VIRGINIA ELECTRIC AND POWER COMPANY
RICHMOND, VIRGINIA 23261

VIRGINIA ELECTRIC AND POWER COMPANY
NORTH ANNA POWER STATION UNITS 1 AND 2
RESPONSE TO NRC REQUESTS FOR ADDITIONAL INFORMATION
PROPOSED TEMPORARY TECHNICAL SPECIFICATIONS CHANGE
SERVICE WATER SYSTEM PIPING REFURBISHMENT

RESPONSE TO NRC REQUEST FOR ADDITIONAL INFORMATION PROPOSED TEMPORARY TECHNICAL SPECIFICATIONS CHANGE SERVICE WATER SYSTEM PIPING REFURBISHMENT NORTH ANNA POWER STATION UNITS 1 AND 2

Figure 1
Service Water System Simplified Diagram

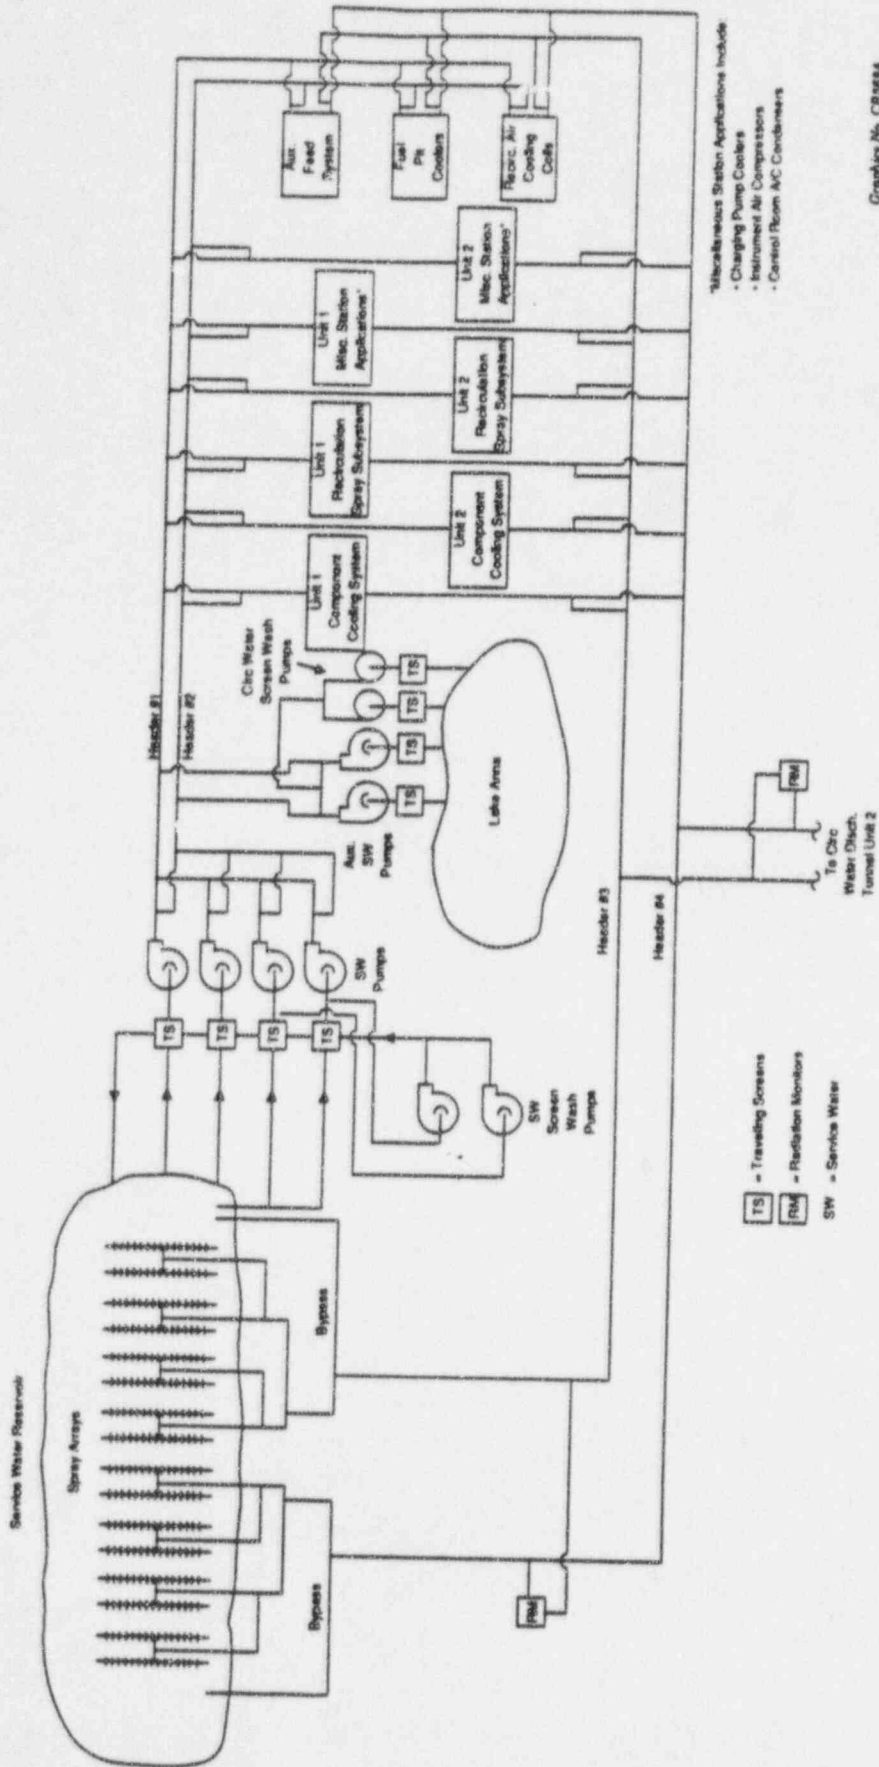
3. During the SWS repair, cooling of the CCW heat exchangers will be provided exclusively by either the Unit 1 or the Unit 2 SWS and the SWS of the other unit will only be available to supply cooling water for the other SWS heat loads. The licensee is requested to describe any special SWS alignment requirements (should any exist) that the plant operators must be aware of while the SWS inspection and repairs are being completed for the following situations:
 - a. during normal dual-plant operation;

In order to discuss the special SW system alignments which will be necessary during project implementation, it will be helpful to briefly describe normal SW system design and operation. In general, the SW system at North Anna is a common system, shared between Units 1 and 2. The two main loops are composed of 36-inch and 24-inch diameter piping which form the main supply and return headers. Each of the two main loops include branch connections to the Unit 1 and Unit 2 components cooled by SW. While any of the four pumps can be aligned to either supply header, one Unit 1 pump and one Unit 2 pump are normally aligned to each of the two main supply headers. The number of operating pumps varies between two and four depending on plant conditions and seasonal climate conditions. Normal SW system design and operation requires both main SW loops to operate continuously during all plant operating modes.

Figure 1 (see following page) provides a simplified SW system diagram. For convenience, the two main supply headers are designated as Header #1 and Header #2 and the two main return headers are designated as Header #3 and Header #4. One main SW loop ("A" loop, as described in the March 30, 1995 submittal) consists of supply Header #1 and return Header #4 and the other main SW loop ("B" loop) consists of supply Header #2 and return Header #3.

Individual components which are supplied with SW for cooling are normally dedicated to one of the two main loops. For example, the Unit 1 CCHXs are normally supplied by Header #1 and the Unit 2 CCHXs are normally supplied by Header #2. There are certain exceptions to this normal alignment. The coolers associated with the charging pumps (gear box, seal, and lube oil coolers) are normally aligned to both Headers #1 and #2. This alignment is provided to ensure uninterrupted SW flow to these coolers in the event of a spurious failure of one of the main headers. Therefore, each main SW loop

The above summary describes the SW system design and operation during normal dual-unit operation. As described in the March 30, 1995 submittal, this normal system alignment is required to be temporarily altered to gain access for refurbishment of the SW piping to/from the CCHXs. Two special system alignment configurations will be necessary to isolate the subject piping and accomplish the refurbishment activities during each of the requested 49-day pipe refurbishment periods.
